A30 Chiverton to Carland Cross Improvement

Deadline 6 Representation from the Harvey Family

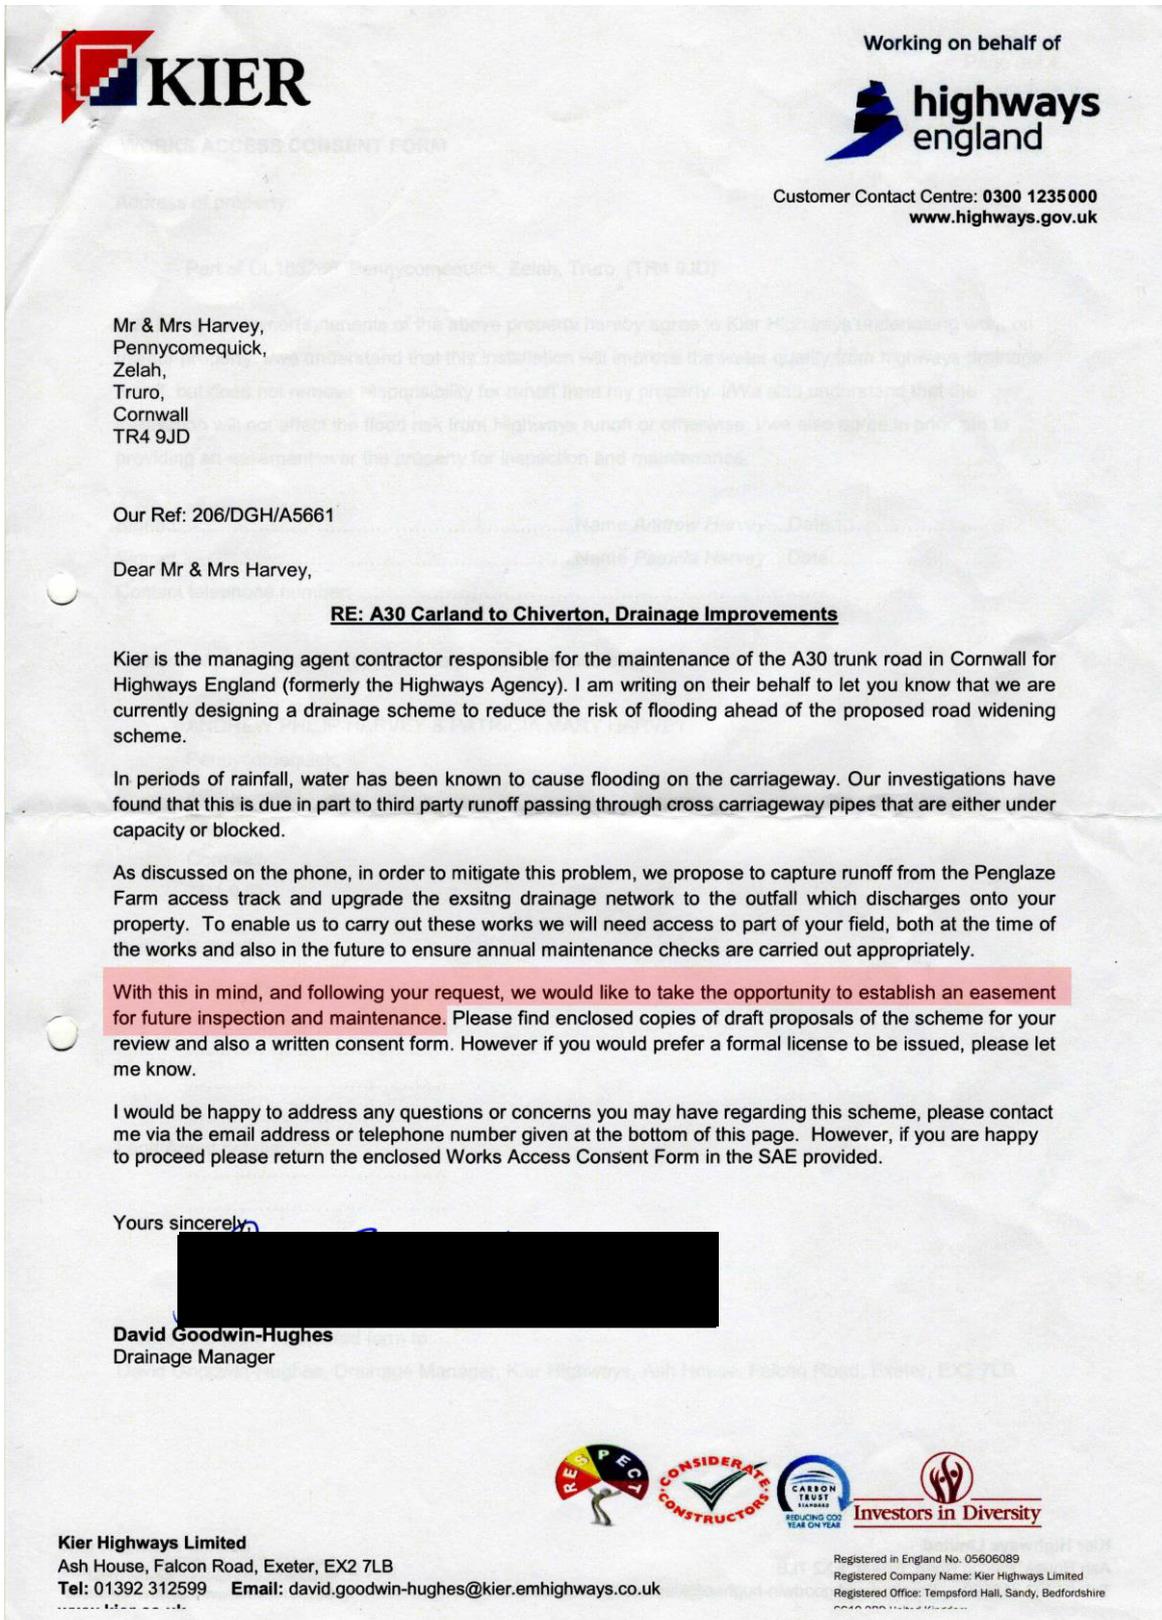
- 4.22. Viewpoint 23 is described as "*A narrow, enclosed view from the back entrance to Pennycomequick, looking southeast along the unclassified local road. The view is framed by mature deciduous hedgerows either side of the road, which restrict and filter views east and west into the wider countryside. The dominant element in the centre of the frame is the unclassified local road*". This time, the photograph is of some value but its use is severely limited as this length of the lane is to remain much as it is and will provide a gated emergency access from the new A30. Had the photographers stood just 15m further back (by our entrance as claimed), they would have been able to show a change of considerable magnitude as the trees and mature hedgerow on the left (first half) are to be felled, sacrificed to the scheme. See Viewpoint A in Appendix GG.

- 4.23. We think that there would be a great benefit in showing those landscapes that are going to change and how – the ‘before’ and the projected ‘after’ shots. If the Applicant can produce a smart video showing how the new road will look, surely a few photographs could be rendered without too much trouble. For instance, the new A 30 should be shown running across the photograph on a slight embankment in VP 23.

Hawthorn growing between the Wildflower Meadow and the Attenuation Pond field

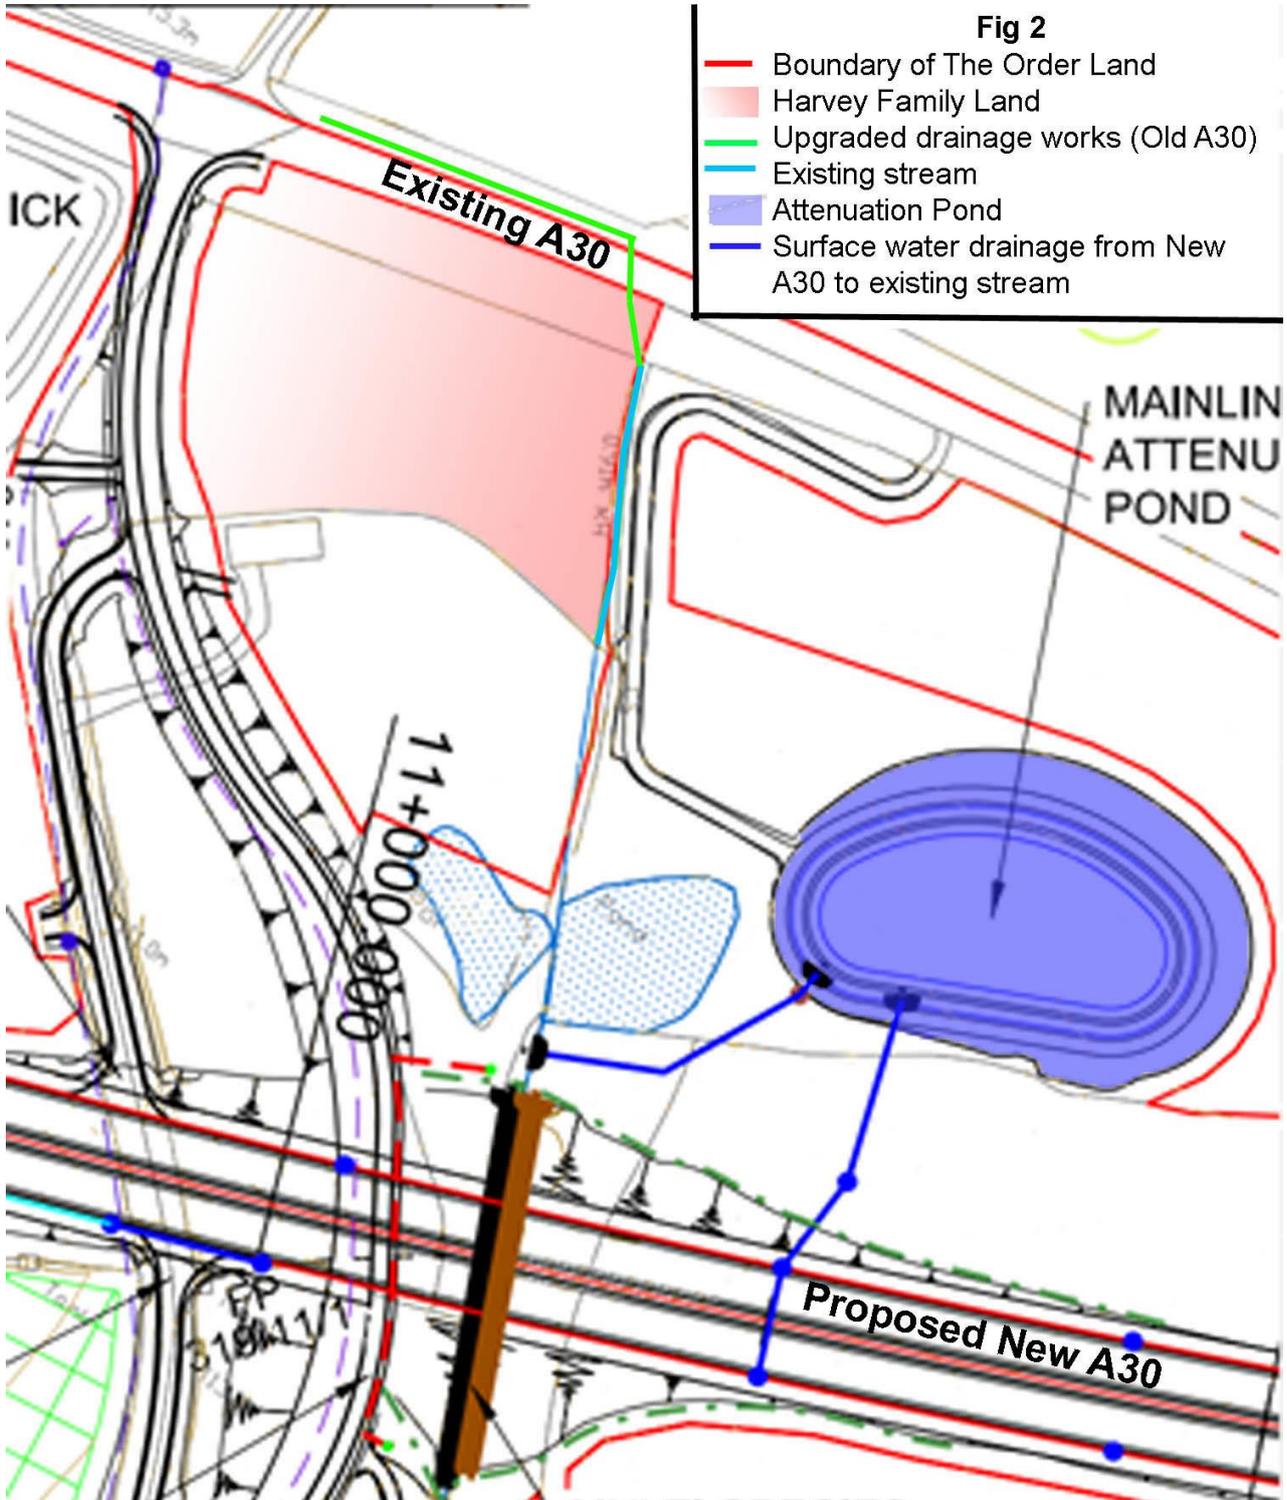
1.13.1. Construction: Appendix EE clearly shows the new Attenuation Pond lying some 50m to the east of the stream with a new vehicular drive to it accessed from the existing A30. Not apparent from the sketch plan is the maturing Hawthorn (*Crataegus monogyna*) trees along the boundary between the Attenuation Pond field and our Wildflower meadow, together with a Cornish hedge (Appendix BB). Together these two structures retain stock and will prevent access for construction purposes unless destruction of vegetation, the trees and the Cornish hedge is intended.

1.13.2. Sheet 15 of 7.6 Environmental Masterplan shows the stream and Cornish hedge between the old and proposed new A30 is hatched red, i.e. to be “Protected & Retained”. These Hawthorn trees, being wind tolerant, are a feature of this part of Cornwall. They are described by The Wildlife Trust as *“In May, Common Hawthorn erupts with masses of creamy-white blossom, colouring our hedgerows. During the autumn and winter, red fruits known as 'haws' appear. Common Hawthorn is a rich habitat for all kinds of wildlife, from Hawthorn Shield Bugs and Yellowhammers that feed on the haws, to Wood Mice and Slow Worms that shelter in the thorny thickets.”* The Applicants already intend to fell all the Hawthorn trees on the western boundary of this wildflower meadow (Appendix CC), do they now also wish to fell some on the eastern boundary in order to create an access between the Attenuation Pond and the stream “for construction purposes”. This would be unconscionable.

Examples of the structure proposed for the Pennycomequick Underpass

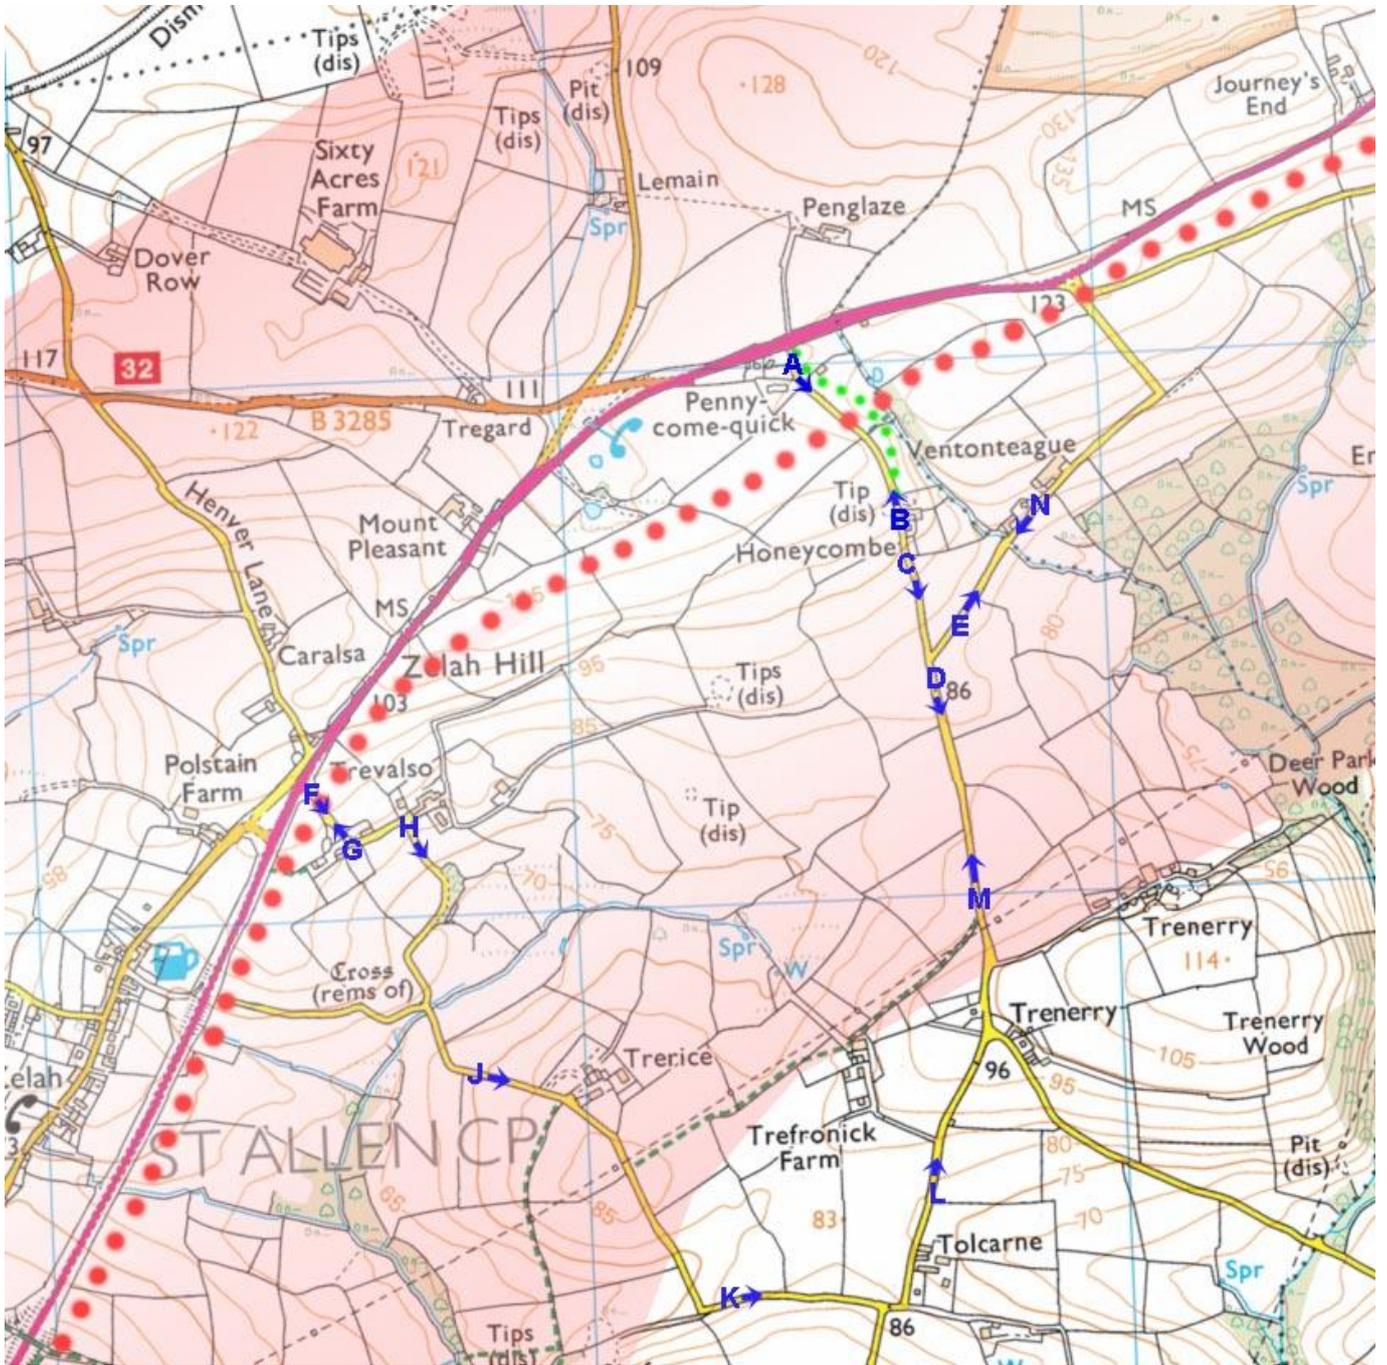
- 4.6. A copy of the images sent to us by the Applicant showing as an example the type of underbridge proposed is at Appendix FF. The Applicants’ intention to use an “off the shelf” design is inappropriate as it does not comply with national or local planning policy and relies on flawed advice.

- 4.9.4. establish or maintain a strong sense of place..."
- 4.10. The intended underpass meets few of these requirements. It may function well, however rather than being visually attractive as a result of good architecture it has a dreadful and depressing appearance. Some of it will admittedly be obscured by tree planting, however a drive down the A30 today between Carland Cross and Chiverton will reveal that within the last few years there has been wholesale clearance of many trees planted on the Zelah by-pass just 20 years previously.
